**FINAL
VOLUME II - RESPONSE TO COMMENTS**

CEQA ENVIRONMENTAL IMPACT REPORT
**SIR FRANCIS DRAKE BOULEVARD REHABILITATION PROJECT MARIN
COUNTY, CALIFORNIA**

STATE CLEARINGHOUSE # 2016122032

March 2018

Figure 27 Example Scenario East-West Roadway and Receptors Placements for CAL3QHCR

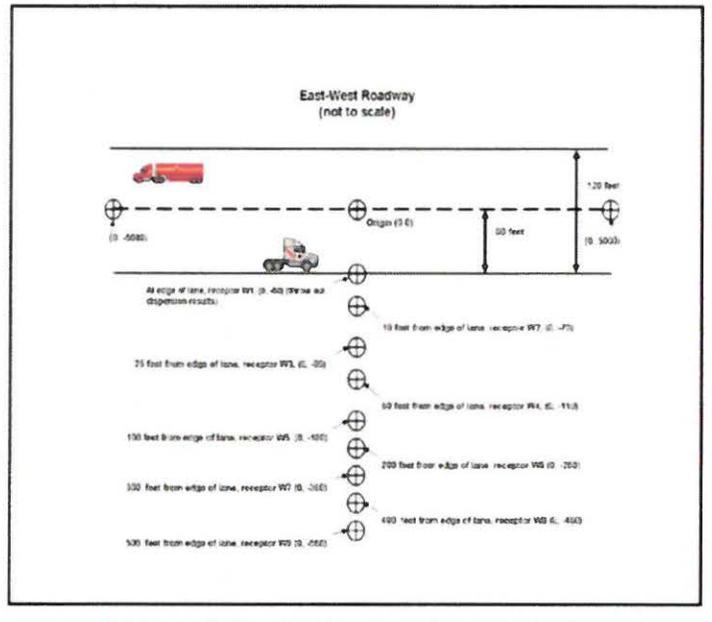
"Figure 27 [from Risk Modeling Approach, copied below] illustrates the example scenario described in this section ... The District recommends using a receptor grid that encompasses the length of the roadway and has receptors spaced every 50 to 100 meters."

This comment goes on to describe the BAAQMD's modeling process for new roadway projects, which is noted. However, the project would add sidewalks, curb ramps, crosswalks, and other roadway modifications as described in Section 3.0 Project Description of the Draft EIR. As shown Figure 3.11, Sir Francis Drake is an existing roadway. The project would not change the annual average daily traffic or roadway configuration other than the additional lane described above; therefore, as stated on page 127 of the Draft EIR, the project would not be expected to result in a significant impact. Following the screening procedures outlined in the referenced BAAQMD document, the project would screen out of additional modeling analysis requirements because the project would not result in a new roadway source of emissions. Dispersion modeling is not required.

FIGURE 3.18

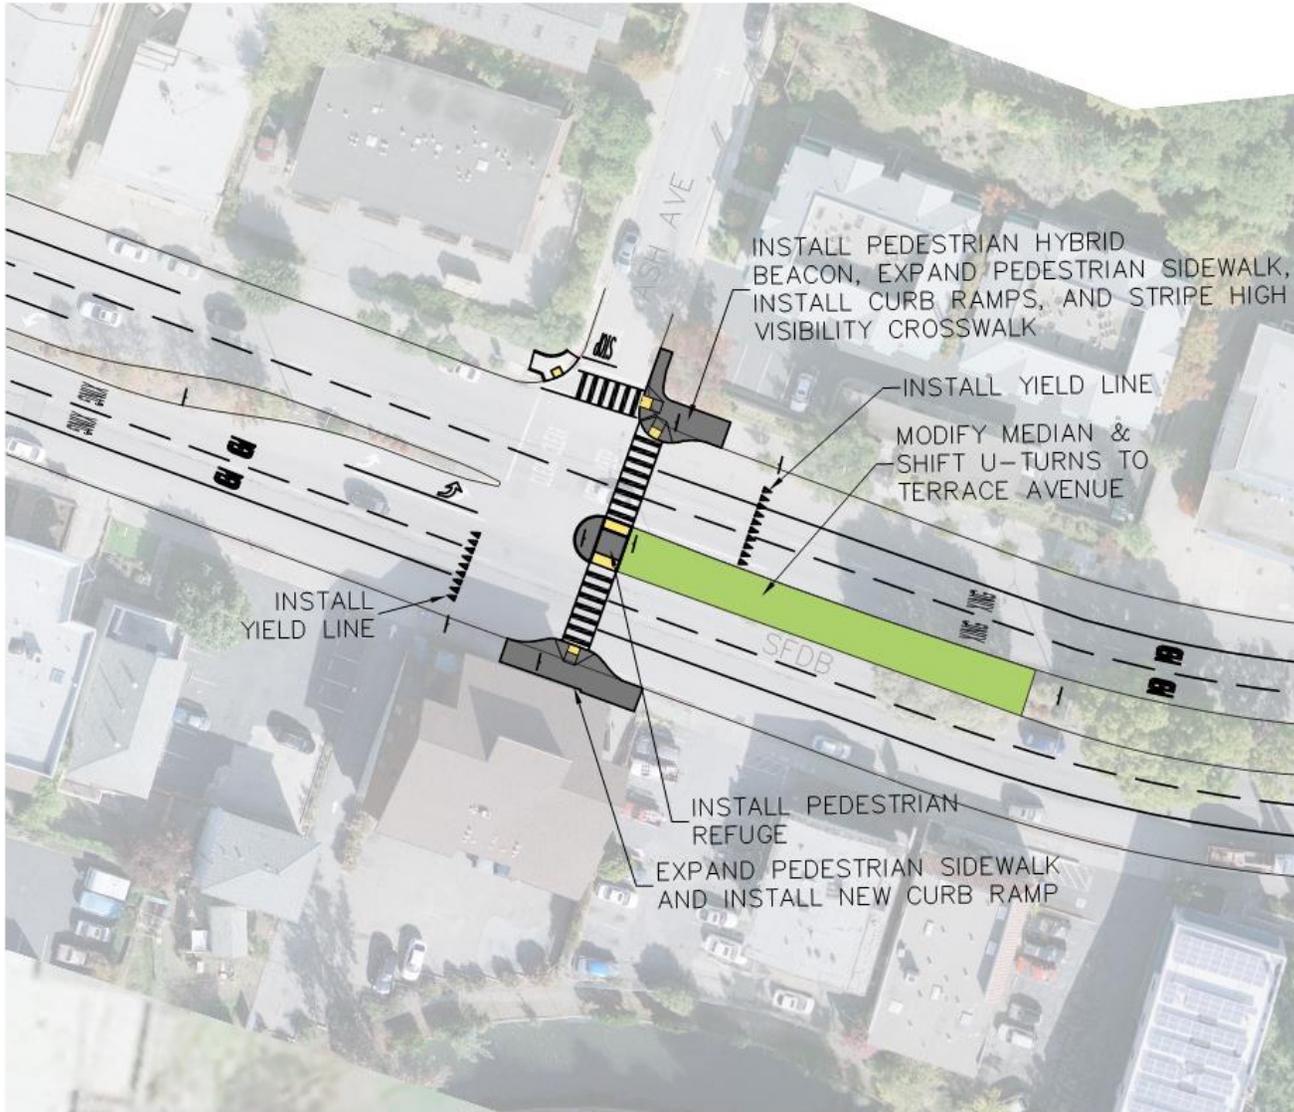
3. Multifamily housing exists along SFD from McAllister Avenue to the Ross City Limits.
4. Figure 3.18. There is no office called Marin Senior Care in the building on SFD near Ash. No organization that would expect a more-than-average number of seniors to visit is in this building.

B1-4: The comment asserts that Figure 3.18 in the Draft EIR is incorrectly labelled. Figure 3.18 has been revised to address this comment. The revisions to this figure do not result in any changes to the environmental analysis included in the Draft EIR.

Page 77, Figure 3.18 has been revised. Please see following page.
